**Attachment C: Tables of compliance (not included in report)**

**Randwick Development Control Plan – UNSW Kensington Campus**

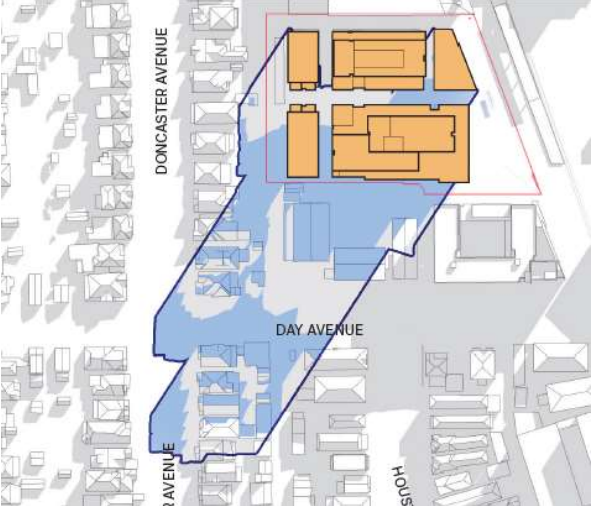
Section	Requirement	Compliance comments
<b>Campus Design Principles and Provisions</b>		
		 <p data-bbox="767 589 1305 618">View 10 Corner of Day Ave and Tunstall Ave.</p>  <p data-bbox="767 1005 1161 1034">View 11 Day and Cottenham Ave</p>  <p data-bbox="767 1408 1145 1469">View 12 Houston Road to south to UNSW.</p> <p data-bbox="767 1514 1361 1664">Anzac Parade: The towers will dominate and transform the relationship with existing buildings on the adjoining sites at New College and NIDA which generally comply with the current DCP 24m height maximum heights.</p> <p data-bbox="767 1709 1361 1984">The towers are also anticipated as transforming the future relationship of buildings setting a poor precedent for heights along this stretch of Anzac Parade which are also subject to 24m maximum heights under the current provisions as well as anticipated emerging character of development in such close proximity to low to medium density zones as well as other areas of the UNSW campus.</p>
